December 22, 2015

Public Works and Government Services Canada
201-1800 11th Avenue, Broad Street Crossing
Regina, Saskatchewan

Re: Food Services Building – Investigation of Saturated Crawlspace

Drawing title/Titre du dessin
BASEMENT & CRAWLSPACE PLAN

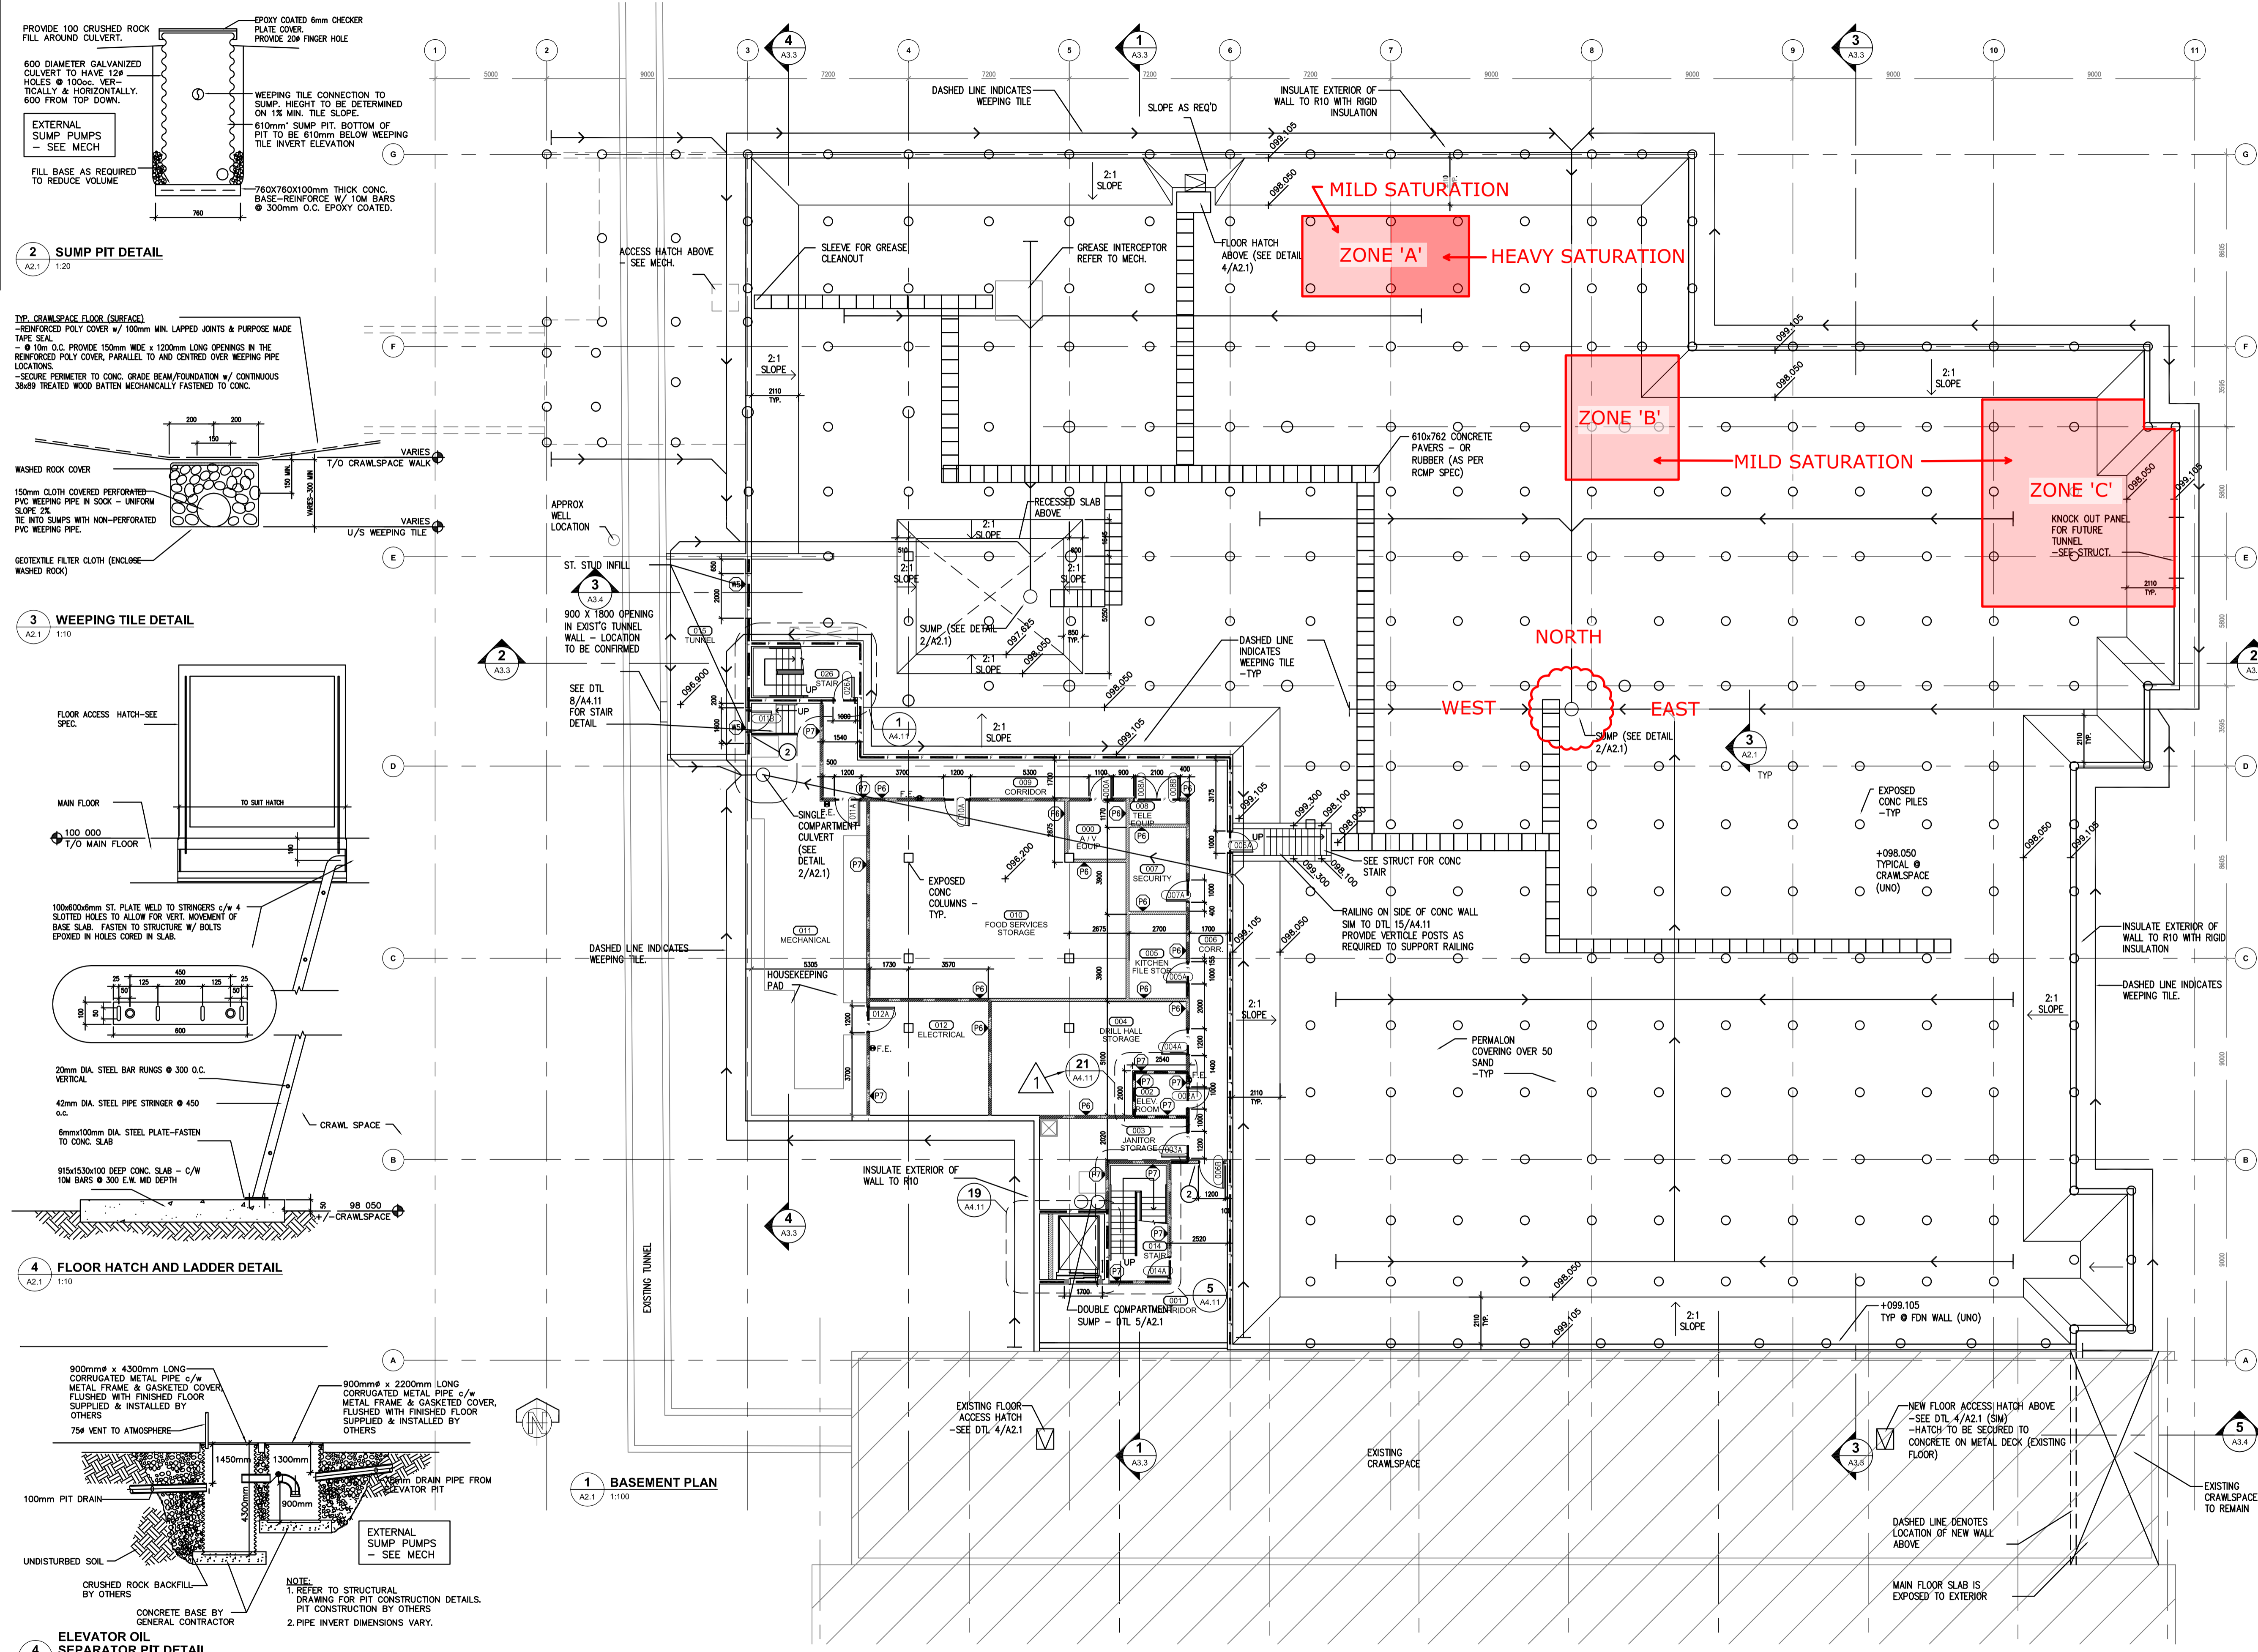
There were three notable locations of sever water saturation and these are identified on the attached weeping tile drawing (A2.1) of the crawlspace. The following report will serve to identify possible rationale as to why the saturation is occurring based on our findings and go to provide recommendations in providing further in-depth investigation.

The writer, while en-route to the other notable exposed area of the crawlspace floor (Area “C”), found Area “B” to also be very saturated (see drawing A2.1 attached). The permalyn had not been removed in this area however the soil beneath the permalyn was found to be very soft. The permalyn was not removed and the writer took note of the extent of size of saturation evident and this is shown on the attached drawing.

In reviewing the attached drawing A2.1 the writer identified the sump pit located west of grid 8 between grids E-D as the sump pit servicing weeping tile routed through or adjacent those saturated areas of crawlspace floor noted above.

One possibility is the weeping tile shown as entering the crawlspace below the grade beam on grid G could be crushed or disconnected. If indeed the line has been installed in this approximate area and is a non-perforated line as required, sloped to the sump pit correctly, then the only explanation is a portion of the line at the interior of the crawlspace has been crushed or a connection, either below the grade beam or along the weeping tile, has become disconnected. This would mean the water entering the weeping tile below the grade beam would migrate to the noted areas "A" and "B" as they are in close proximity of the entry point.

The use of Non-perforated weeping tile is a requirement for the "main connection runs". These main connection runs tie into the exterior perforated perimeter weeping tile at the grade beams and the interior crawlspace perforated weeping tile also connect to these main connection runs which are routed to the sump pits. Detail 3/A2.1 on attached drawing A2.1 (*Basement and Crawlspace Plan*) clearly identifies the perforated weeping tile required within the interior of the crawlspace and is to be connected to the Non-perforated weeping tile which is then routed into the sump pits. This is evident by the notation under detail 3/A2.1 "tie into sump pits with non-perforated PVC weeping pipe".

We recommend a camera be used to scope the weeping tile from the sump pit up stream as far as possible. This further investigation could reinforce our findings as to the possibility of a crushed or disconnected weeping tile at point of entry into the crawlspace or other possible locations, the non use of perforated weeping tile as main connection runs and a poor slope of weeping tile trenches.
